Technical Service BULLETIN

Title: **SLIDING DOOR RATTLE**

Models: '04 – '06 Sienna

NV001-06

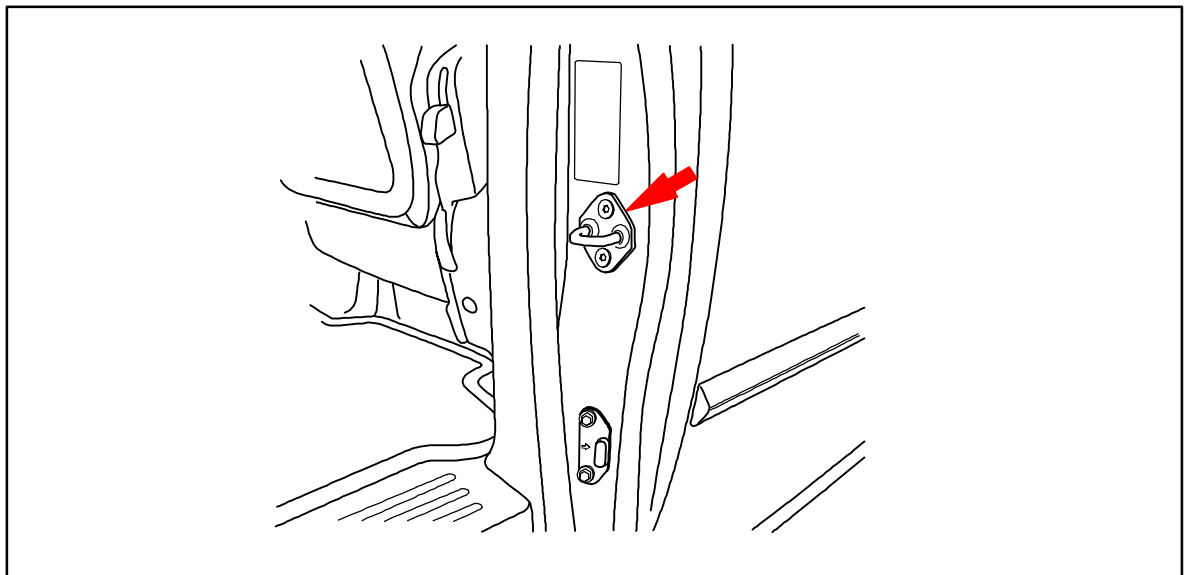
The sliding door front striker plate and lock assembly on 2004 – 2006 model year Sienna vehicles have been redesigned in order to address customer complaints of rattles that occur under certain driving conditions. The improved front striker plate and lock assembly have a new coating that will reduce noise from contact between the front striker plate and the sliding door lock assembly when in the closed position.
